**RE: PROPOSED INTEGRATED TOURIST FACILITY - 24 & 25 BOX STREET BUDERIM
PEER REVIEW OF REPORT BY CORE CONSULTANTS PTY LTD**

REVIEW OF RESPONSE TO RFI DATED 4 JANUARY 2017

Peer Review
Proposed Development
24 & 26 Box Street, Buderim

Figure 2 – Annual Rainfall (Palmwoods)

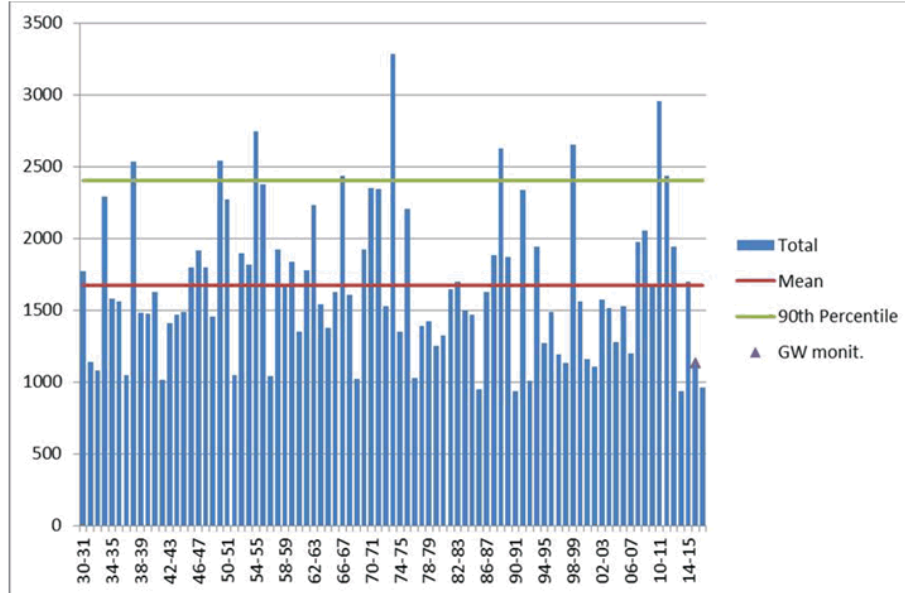
- The assumed groundwater conditions appear to be based largely on groundwater monitoring in September 2015, which Core Consultants indicate (p13) is after 80% of the annual rainfall (at Sunshine Coast Airport). However, referring to rainfall records over a much longer period from Palmwoods (refer Figure 2 below, plotted with rainfall as July-June so that summer rainfall is reported in the same year), the investigation and groundwater monitoring has occurred in a series of years of average or well below average rainfalls. As highlighted in the previous Coffey & Partners reports, because of the fissuring in the Tertiary clays the groundwater levels can rise rapidly in response to rainfall. It is likely that the groundwater levels are highly responsive to rainfall, and undertaking one or two discrete readings is prone to underestimate the likely reasonable extreme case condition that might be experienced.

With this in mind, whilst it would be preferable to obtain groundwater levels over a much longer period including at least one summer of above average rainfall, there should preferably at least be continuous groundwater level monitoring (using in borehole data loggers) in selected key locations with close examination following significant rainfall events.

At the current preliminary phase, it would be at least prudent to adopt more elevated groundwater conditions to be more representative of the 90th percentile case rainfall events (which last occurred in 2010/2011 and 2011/2012 years) to understand the magnitude (and economic viability) of works required to deal with likely extreme rainfall conditions. It is expected that it will be necessary to give detailed consideration to a groundwater control system (and proposed discharge options/approaches) for the project which may be required to cope with significant flows during and after significant rainfall events.

Figure 3 – Building C Excavation Ground Profile

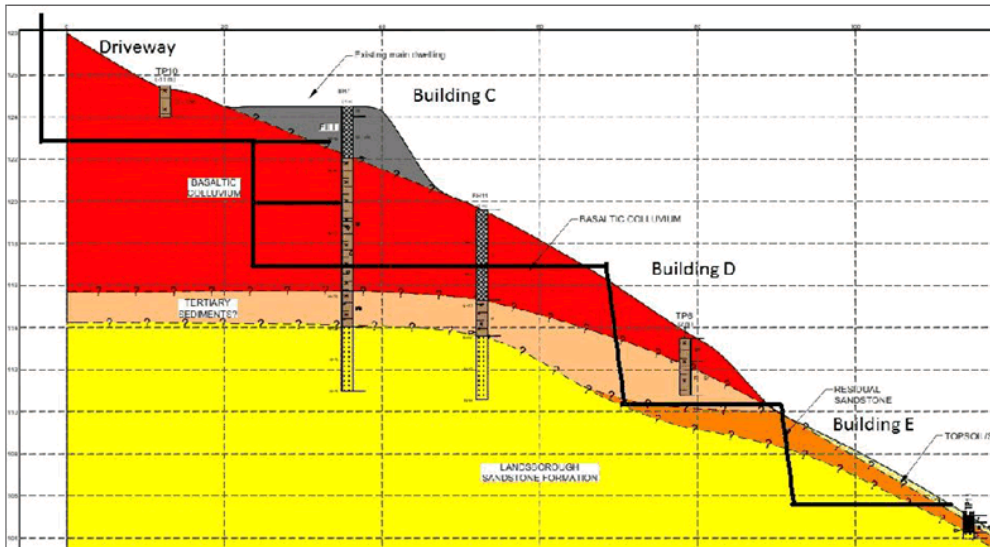
The ground with the highest risk of instability is that where the Tertiary soils are at or close to the surface, in particular in the middle part of the site where Buildings C and D are located. The proposed scheme (refer proposed building excavations superimposed onto the Core Consultants geotechnical cross sections below in Figures to 5) indicates basement excavation to RL117 for Building C, which current geotechnical information suggest will provide a subgrade in basaltic colluvium, with Tertiary

Sediments around RL 116 and Sandstone around RL 114. It is reasonably likely that Building C will require a grid of bored pile foundations into the Sandstone, and these measure will provide a significant stabilising influence for this part of the slope. The Building C basement wall will provide a significant engineering structure to support the slope in that location. The Building D retaining walls will likely require quite extensive engineering measures with continuous positive support (eg soldier pile bored pile wall) because of the presence of the Tertiary Sediments in that location. Given the above, it seems it should be reasonably practical in this part of the site to provide measures that will provide a safety factor of 1.5 for stability.

Figures 3 and 5 also indicate there are two areas where retaining structures will be required to prevent instability in the Basaltic colluvium with a significant slope upwards behind the wall crest. These structures also do not benefit from direct propping from structure (eg basement slabs), and are located close to the site boundary, so permanent anchoring will not be feasible. Mass gravity walls may be a solution but could be very large structures. Given the steep upslope it is considered that it will be highly desirable to maintain positive support at all times with measures such as temporary anchoring (if the neighbour permits) whilst walls are constructed. Further, these walls would be subject to the risk of boulders from upslope areas as indicated in Section 6.1 previously. Given the significant constraints, these walls may be quite significant features and it is recommended that further consideration of the proposed solutions for the walls be undertaken.
